**BOARD ACTION REPORT – APPEALABLE ITEM**

**Project Name:** 226 Palm Court, Hacker Medical Office  
**Project Location:** 226 Palm Court, Del-Ida Park Historic District  
**Request:** Certificate of Appropriateness and Class V Site Plan, Landscape Plan, Architectural Elevations, and a waiver request.

**Board:** Historic Preservation Board  
**Meeting Date:** March 2, 2016

**ITEM:** Class V Site Plan (2015-169) for the new construction of a three-story building consisting of medical office and residential uses on the property located at **226 Palm Court, Del-Ida Park Historic District.**

## PROPOSED SITE PLAN

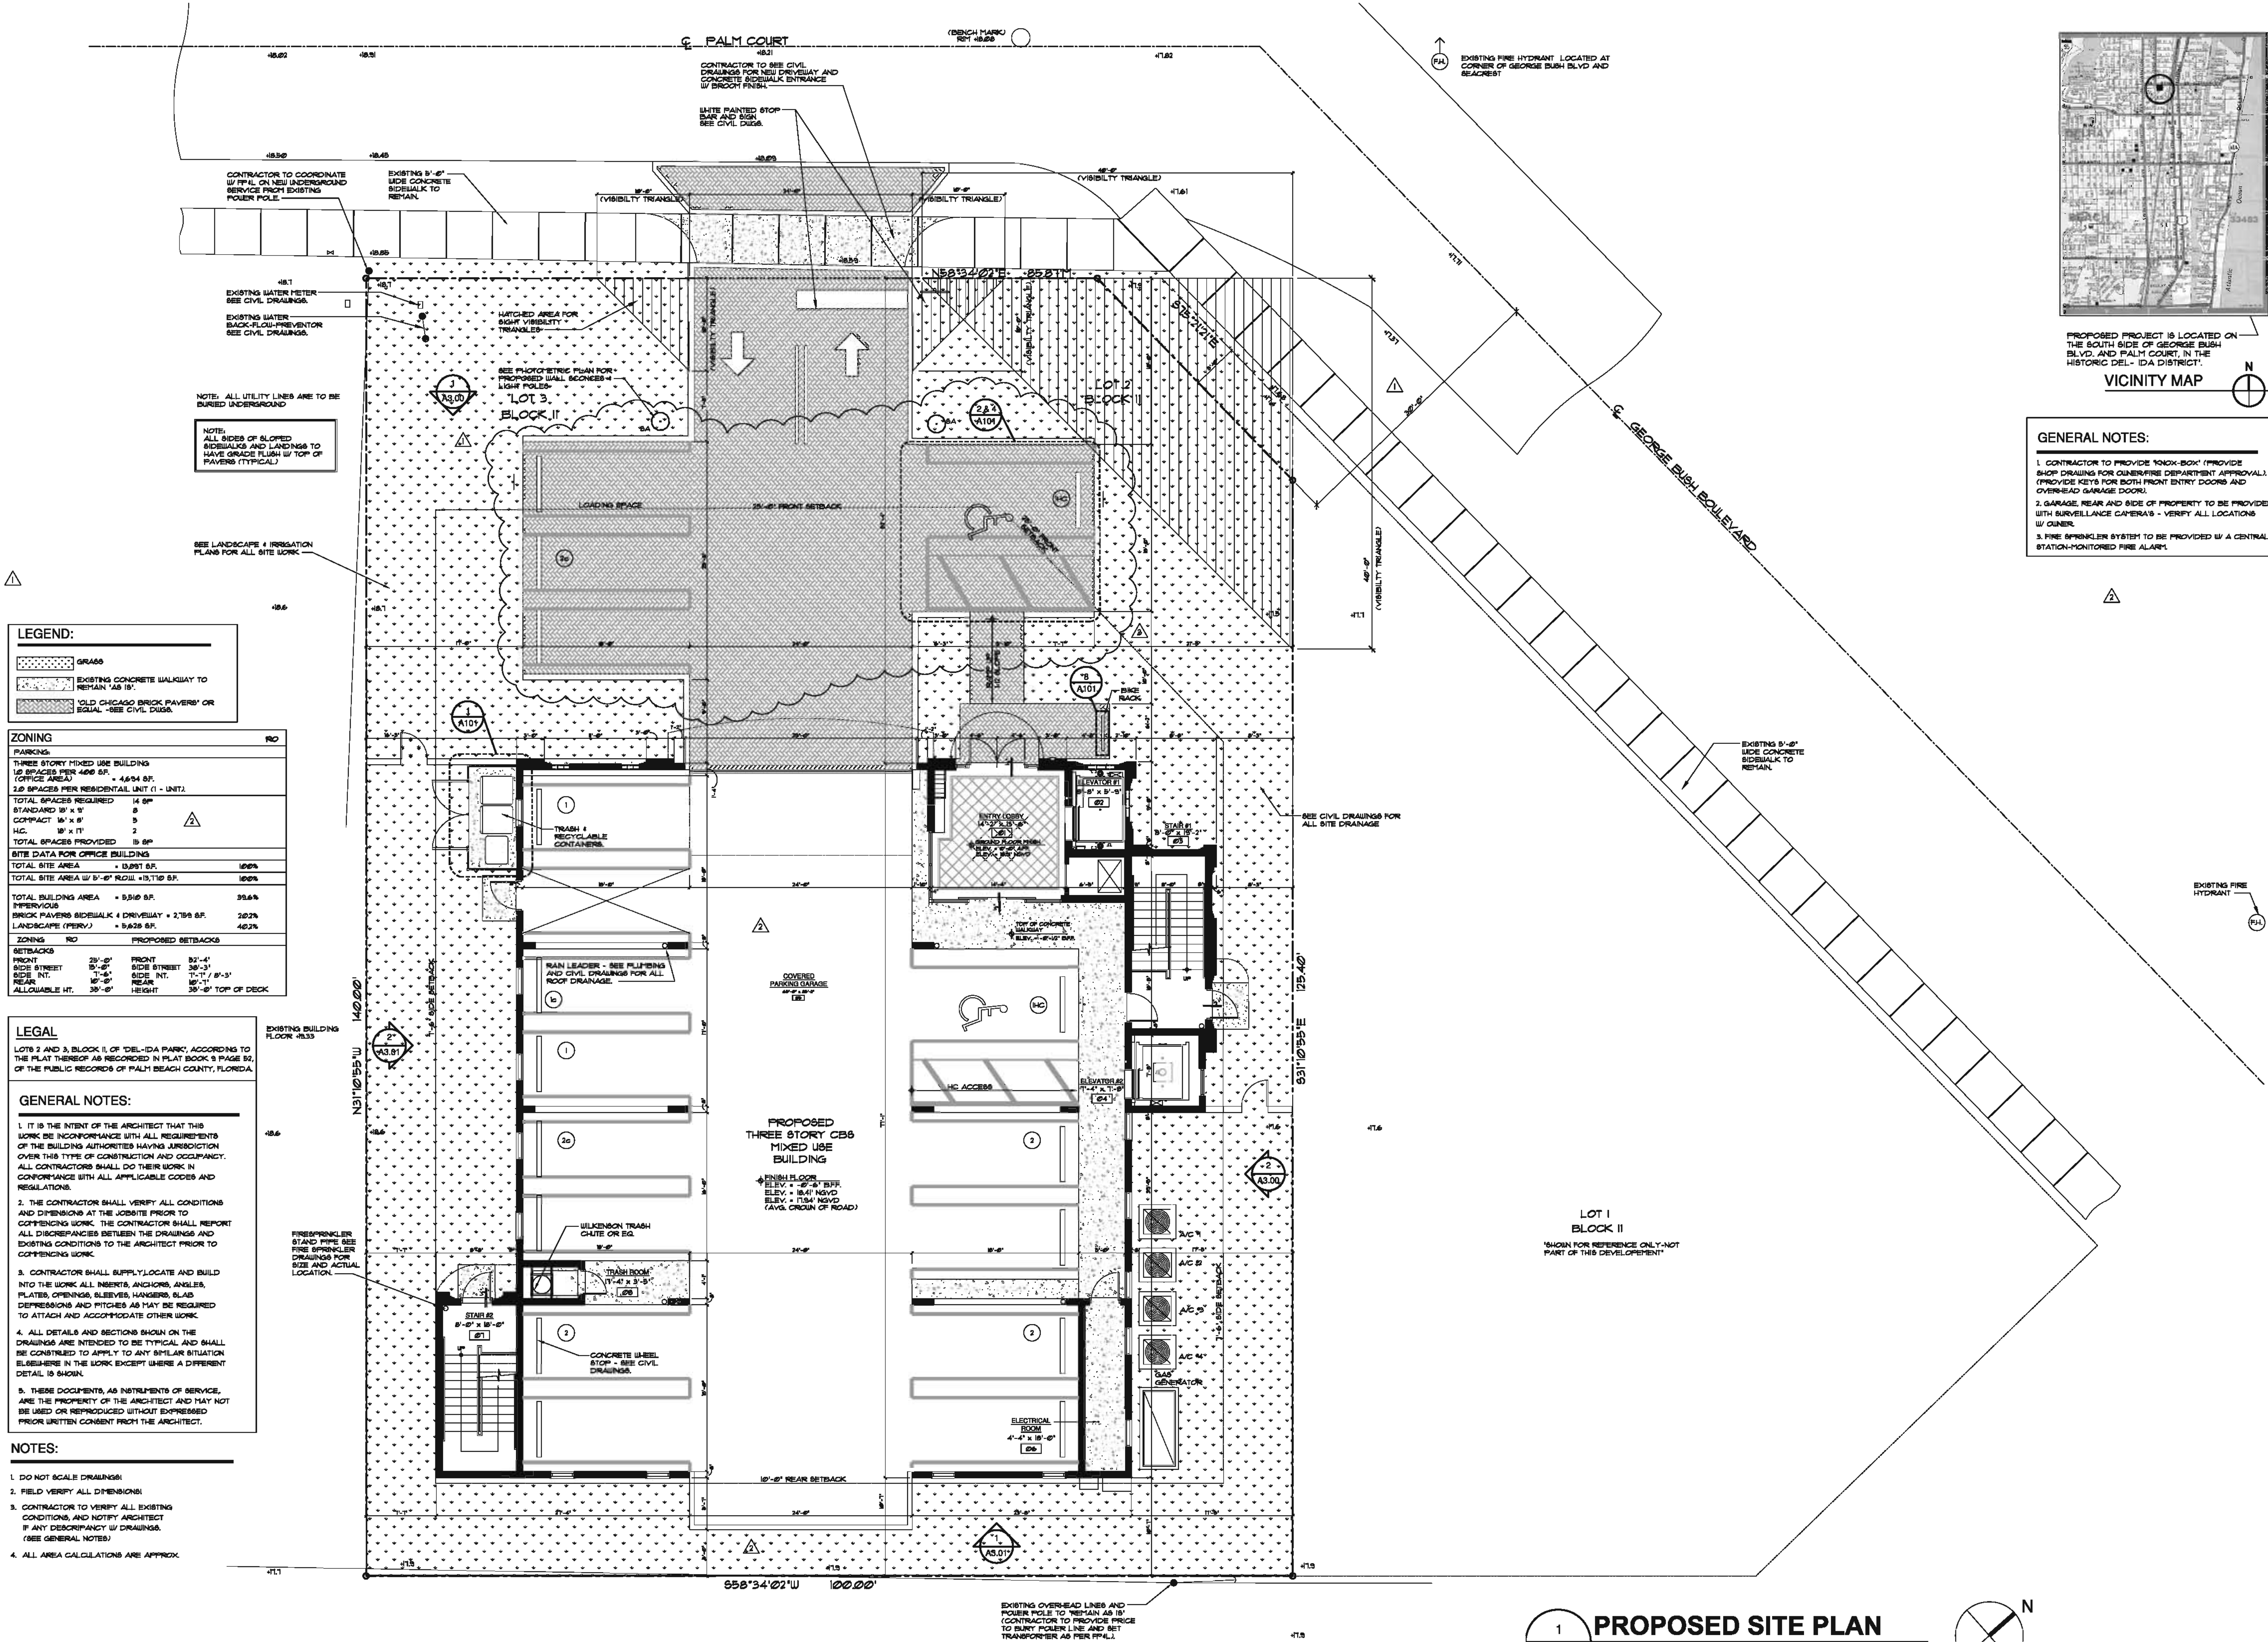
- REVISED 10/22/13 AS PER P&Z COMMENTS:
1. PROVIDED ADDITIONAL 5'-0" ROW.
  2. CREATE LOADING SPACE.
  3. ADDED OVERHEAD GARAGE DOOR & UPDATED PARKING CALC'S.
- REVISED 01/15/16 AS PER P&Z COMMENTS:
1. PROVIDED 5'-0" LANDSCAPE ISLAND.
  2. PROVIDED (1) ADDITIONAL EXIT.
  3. ELIMINATED (1) PARKING SPACE.
- REVISED 2/4/16 AS PER P&Z COMMENTS:
- PROVIDED 6" CURBS IN FRONT PARKING AREA AS INDICATED.

**PROPOSED GROUND FLOOR PLAN**

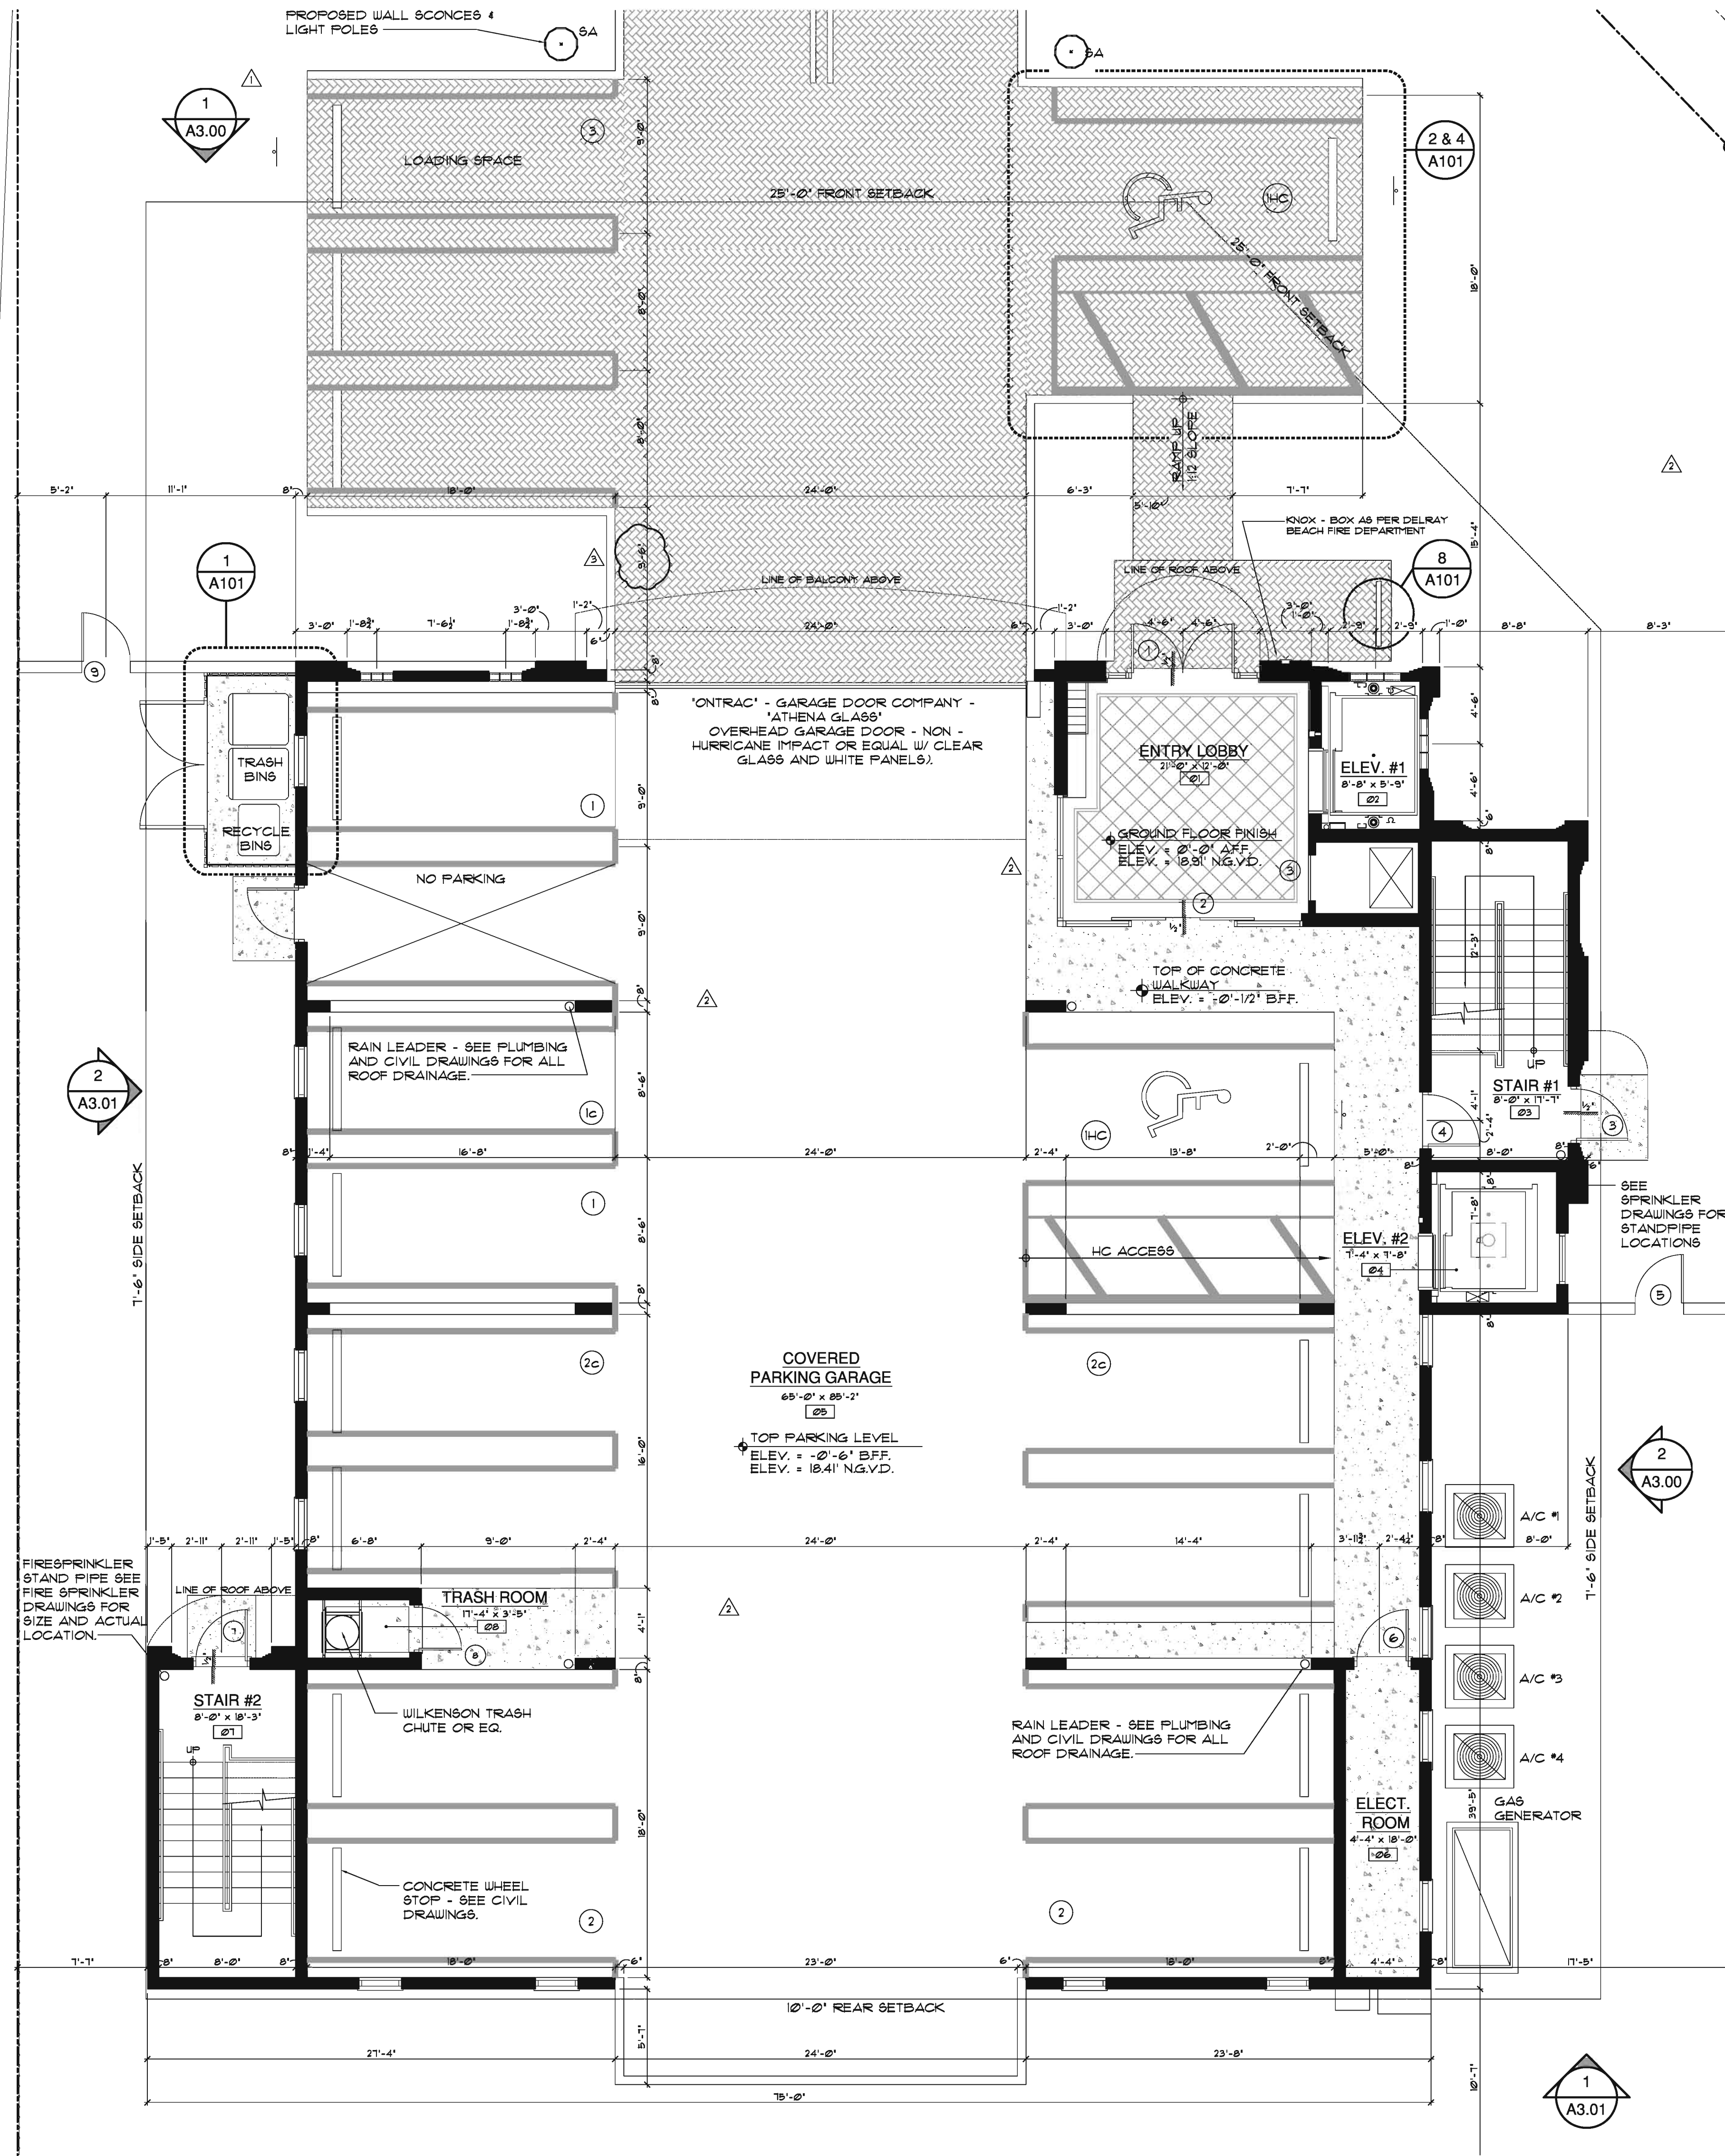
REVISED 10/22/15 AS PER P4Z COMMENTS:  
1. LOADING SPACE & OVERHEAD GARAGE DOOR

REVISED 01/16/16 AS PER P4Z COMMENTS:  
1. PROVIDED 9'-0" LANDSCAPE ISLAND.  
2. PROVIDED (1) ADDITIONAL EXIT.  
3. ELIMINATED (1) PARKING SPACE.  
4. KNOX BOX AT MAIN ENTRANCE. REVISED 02/01/16 AS PER P4Z COMMENTS:  
1. ADJUSTED CONCRETE CURBING.

## A2.02

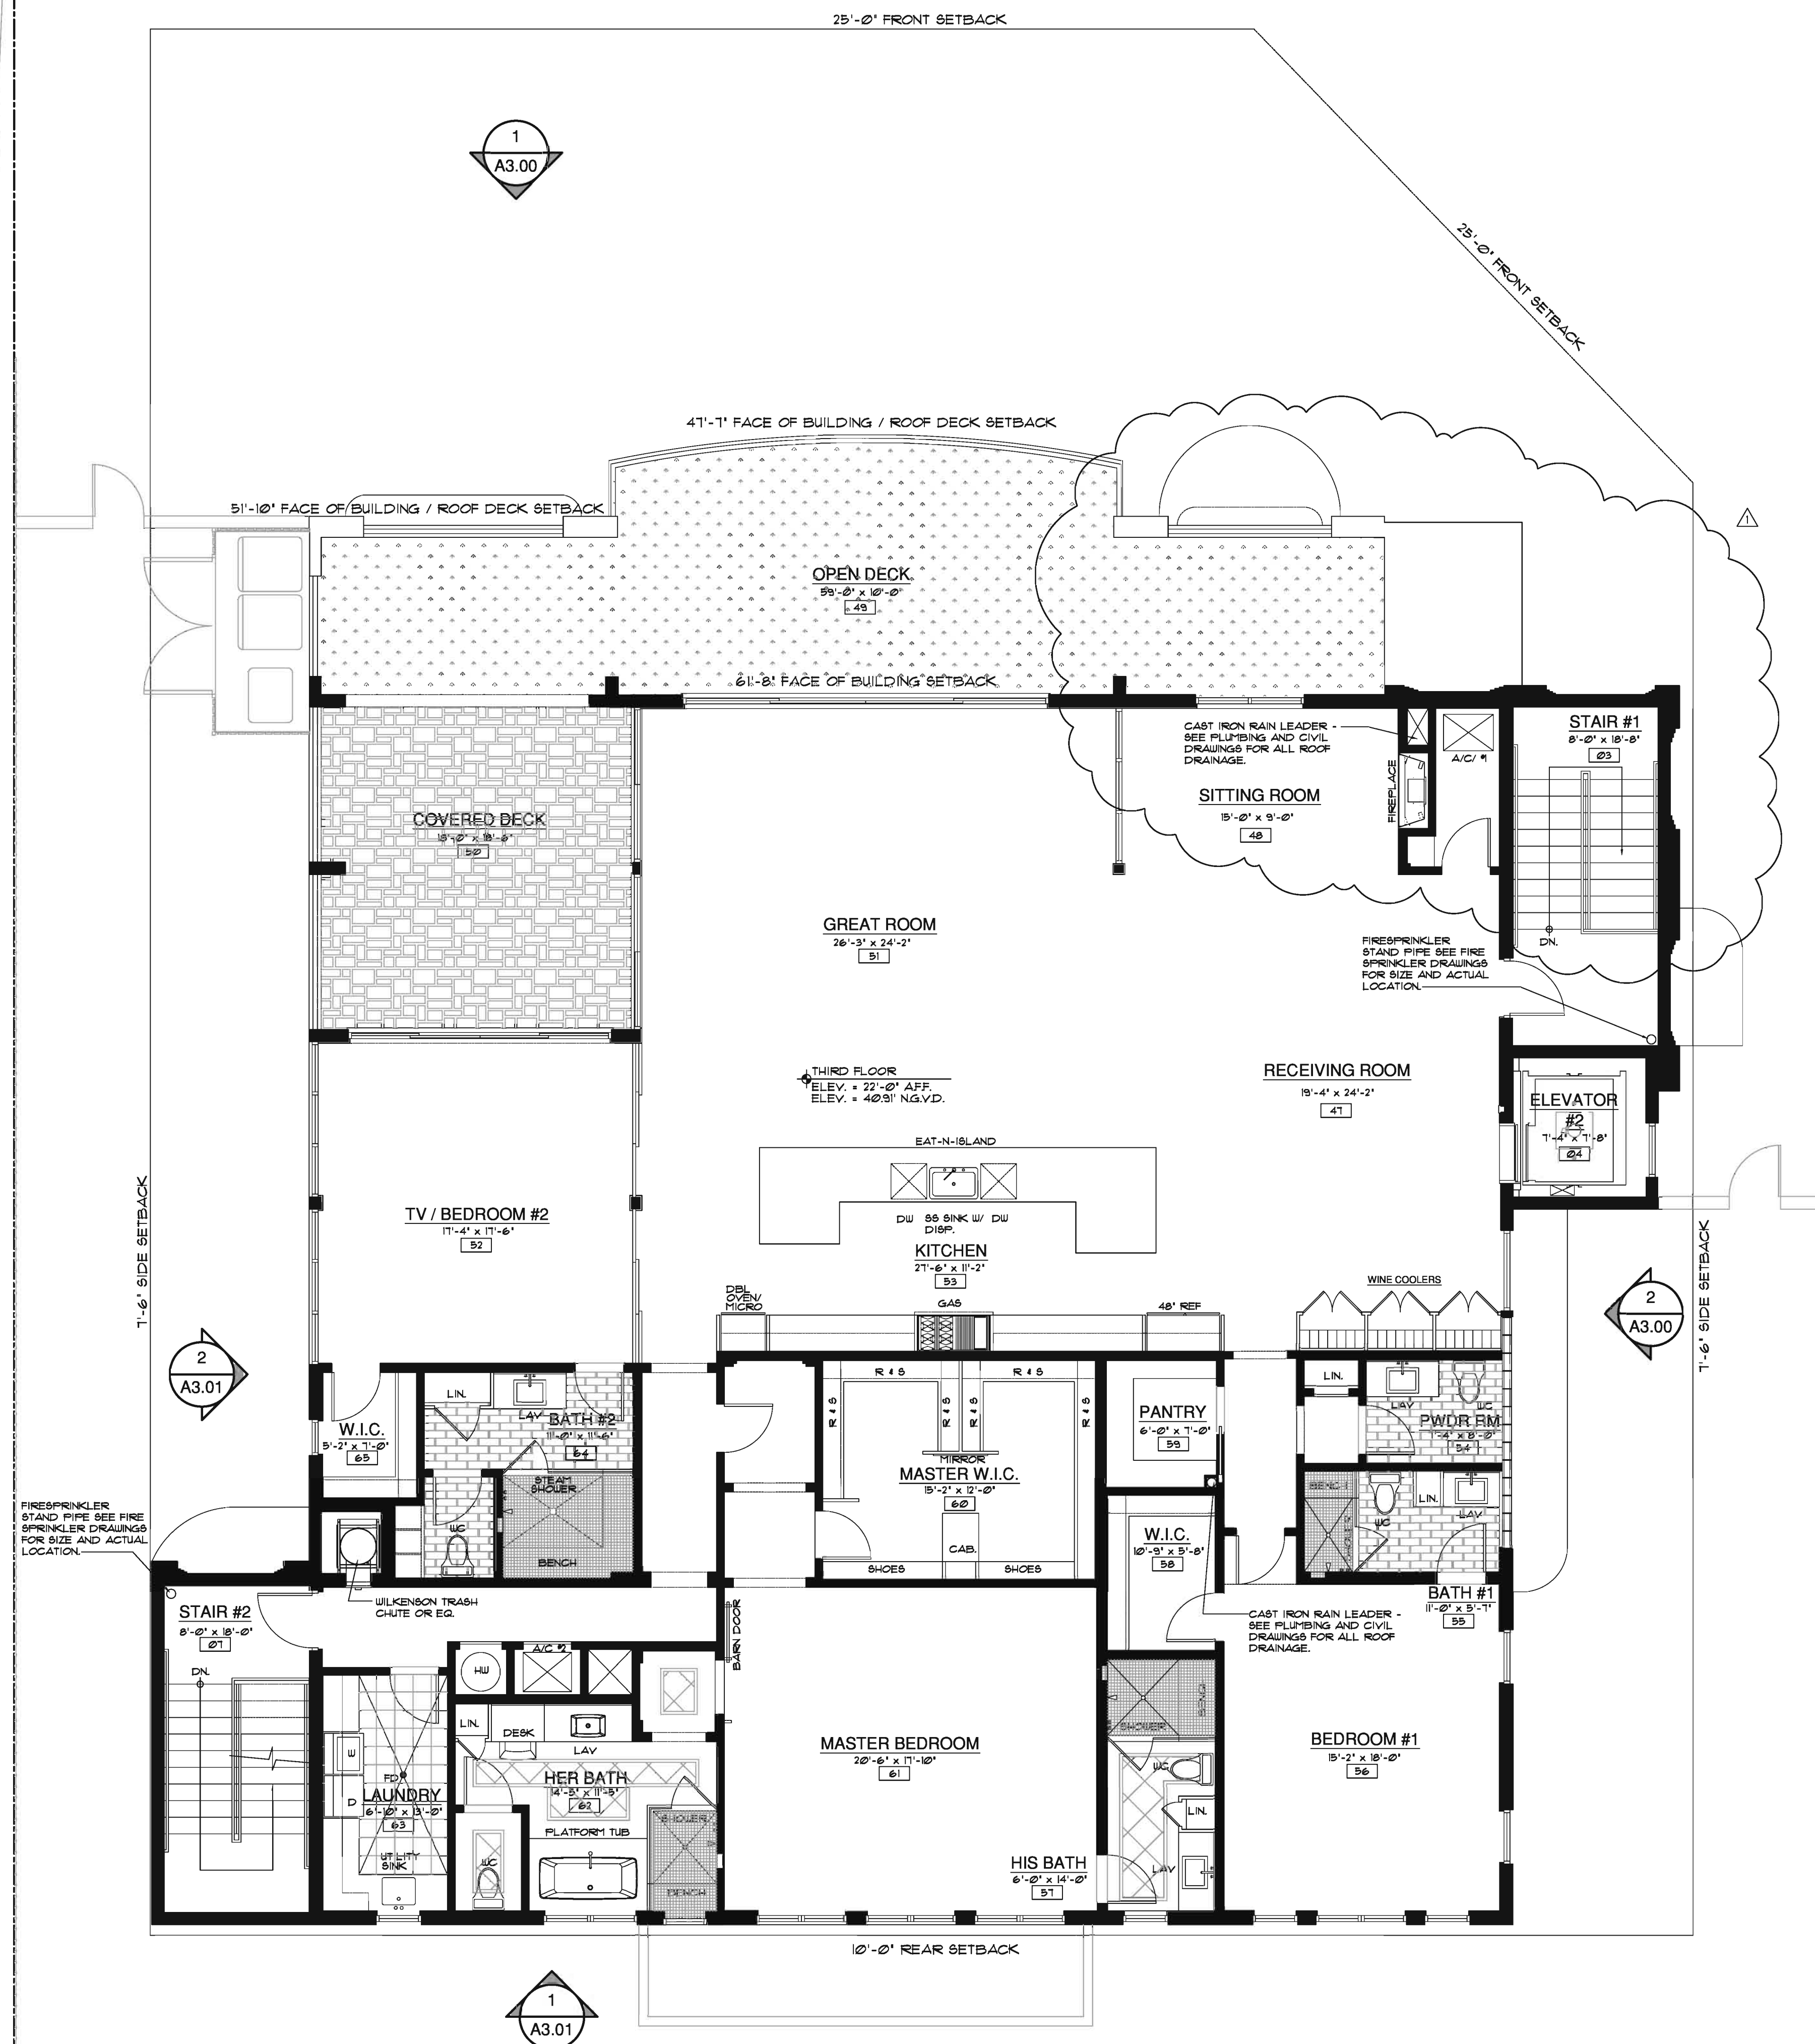
1 REVISED 01.15.16 AS PER P#Z  
COMMENTS:

1. REDUCED WAIVER REQUEST FROM BUILDING HEIGHT PLANE FROM 6'-1" DOWN TO 3'-6".
